**SUBSURFACE WASTEWATER DISPOSAL SYSTEM APPLICATION** Department of Human Services  
Division of Health Engineering  
(207) 287-5672 FAX (207) 287-4172

Street Subdivision Lot #: PT # 17 654 Eastern Ave

Last: TRACY First: QUANE

This is an amendment to Permit #3947 issued on 5/29/98 to Duane Tracy.

SUBSURFACE WASTEWATER DISPOSAL PLAN

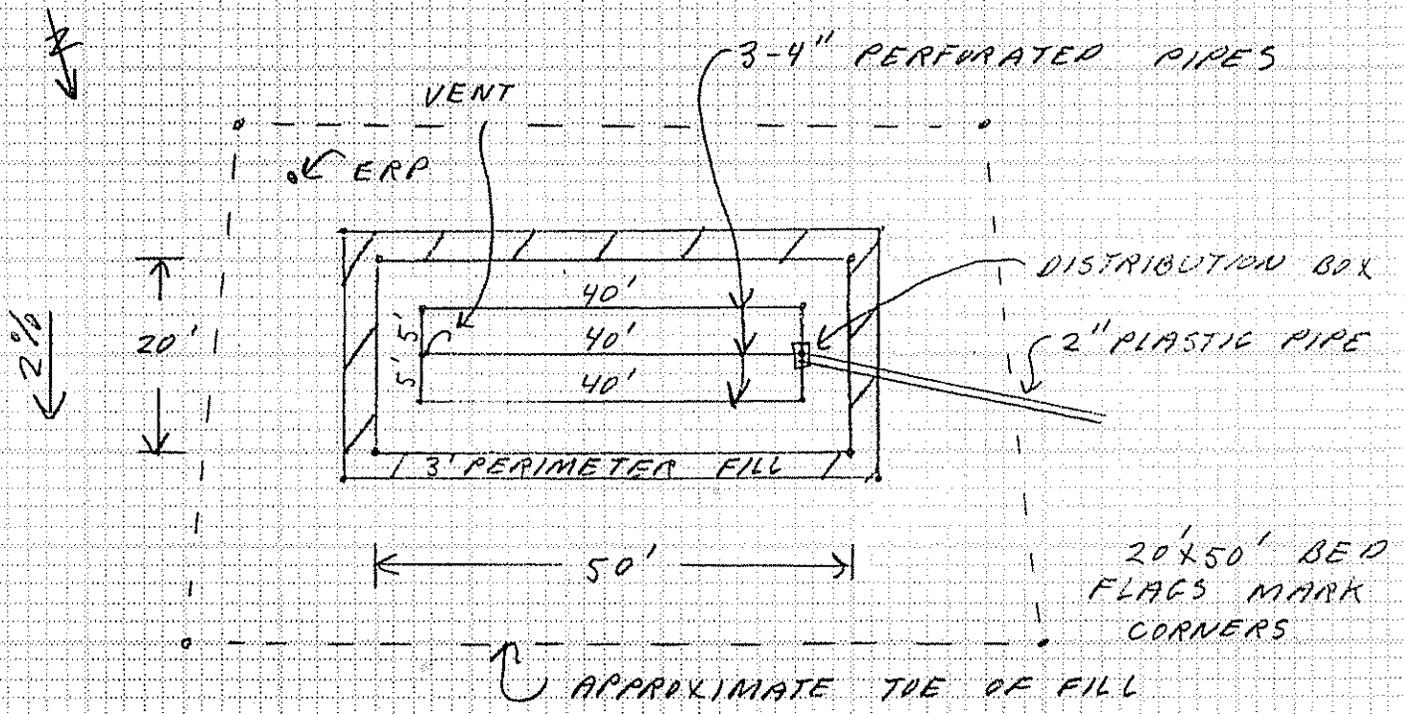
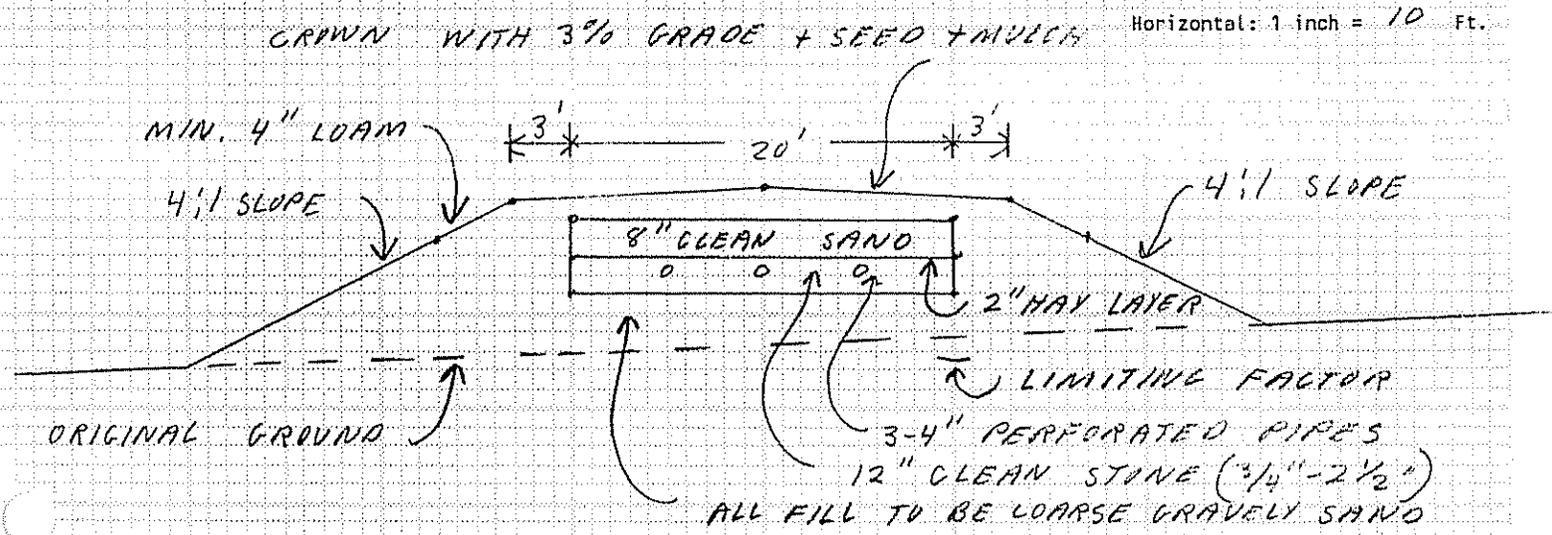
IT IS MY UNDERSTANDING THAT LEDGE WAS EXPOSED EARLY ON ONE CORNER OF DUANE TRACY'S SEPTIC ON RT. #17. IT IS UNDER MY REQUEST THAT THE SYSTEM HAVE AN ADDITIONAL 12" OF COARSE GRAVELLY SAND FILL PLACED UNDER SYSTEM. IF THERE IS ANY QUESTIONS PLEASE FEEL FREE TO CALL ME.
